CHATHAM COUNTY PURCHASING DEPARTMENT

ADDENDUM NO. 3 TO BID# 21-0114-5

FOR: PURCHASE AND INSTALLATION OF AN AV SYSTEM FOR THE CHATHAM COUNTY DETENTION CENTER

CCSO Court Rooms A&B
10/14/2021

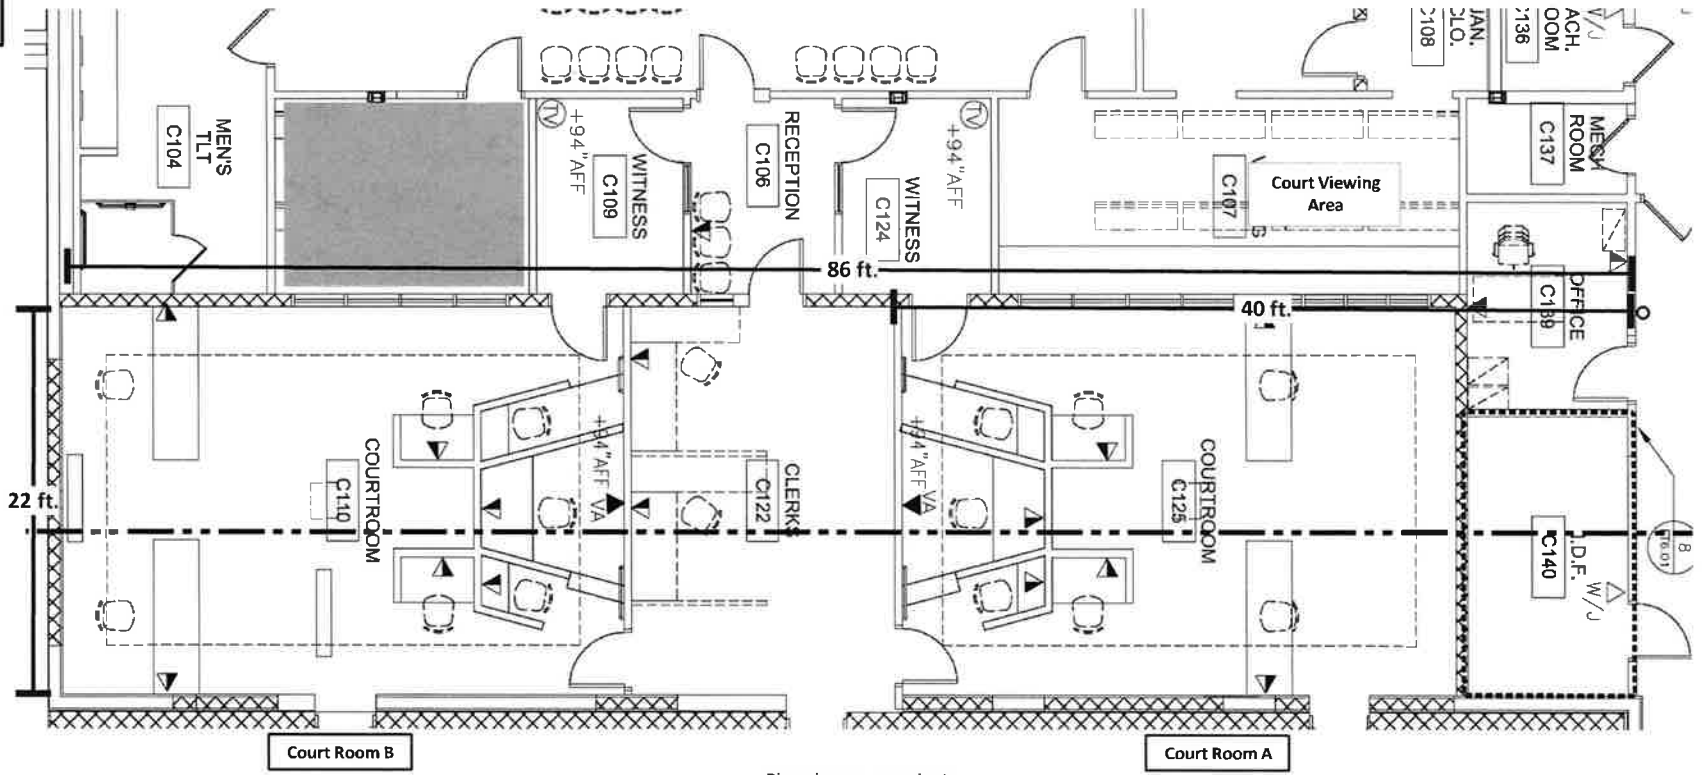
9. **Clarification:** Please see attached drawings of courtrooms A and B.
